DB15 CONNECTOR MOUNTED ON IF OF MODULE. CONNECTED TO IDC16 CONNECTOR MOUNTED ON BOARD VIA MASS TERMINATION CABLE.

Rev	Description	Date
A	Initial Release	10/00
B	1. Changed connection of K5 to correct polarity for coil (Pins 1&6 reversed) 2. PCB traces rerouted for K5 and C64. 3. Hole sizes for PA85 increased to allow sockets. 4. J12 rotated on PCB.	6/01
B1	Swapped pins 10 and 12 on relays K1, K2, K3, K4 and K5 to invert enable signal. Change was done by removing relays from board and adding an interface socket to make the switch.	10/01
B2	1. Changed C47, C45, C74, C72 to 47pF. 2. Changed R88, R83, R137, R129 to 110 ohms. (Better compensation of PA85s)	1/02
B3	Rev B3 revision notes: Rev B3 typically applies to BS, RM, ITMs and ETMs 1. 7.2K feedback resistor is changed to 21.6K ohms (3 ea. 7.2K in series) 2. 1Kohm in series with 5uF is changed to 100K in series with 5uF for BS, RM and ETMs. Remains at 1K for ITMs. 3. 7.2K in series with coil output is changed to 3 ea. 1K in series. 4. 10 ohm current limit resistors on PA85 changed to make a 1.4ohm current limit resistor. 5. DAQ coil output Monitors changed to have 0.05uF capacitor and 10K resistor, making a 300Hz HPF.	9/02

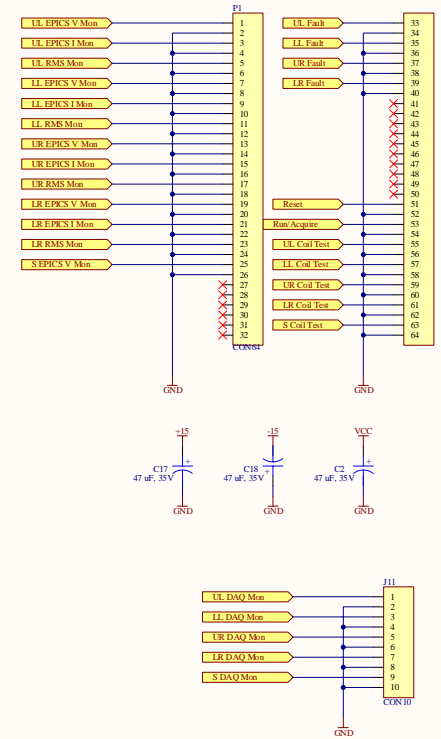
C	Board release incorporating all Rev B changes	1/03
C1	As built changes for LLO ETMs. Cadd1-Cadd4, Dadd1-Dadd16 added to existing rev C boards using wires and direct connections to pins. Diodes added for PA85 protection per APEX app note 25.	1/05
